UDRP Comments 2019 January 23 (including applicant response)

Re: SOUTH MACLEOD CENTRE CALGARY
OUR PROJECT #216065 – 6.1
RESPONSE TO URBAN DESIGN REVIEW PANEL AND DETAILED TEAM
REVIEW 2 COMMENTS
DEVELOPMENT PERMIT NUMBER: DP2018-1300 (LOT 6)

A. Dean, City of Calgary
South Macleod Centre Calgary
Response to Urban Design Review Panel and Detailed Team Review 2 Comments
Development Permit Number: DP2018-1300 (LOT 6)

Figure 1 – South Macleod Centre Area Structure Plan with DP overlay

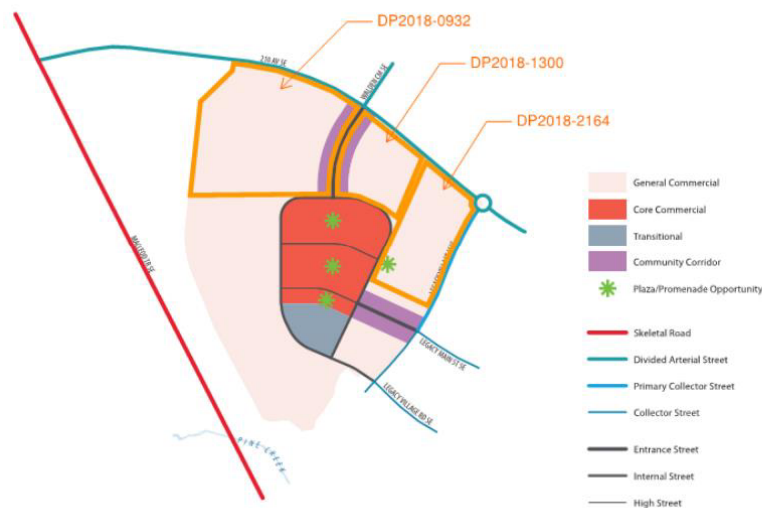
Figure 1 below illustrates the ASP Concept Plan with the locations of the three current applications overlaid on the Masterplan.
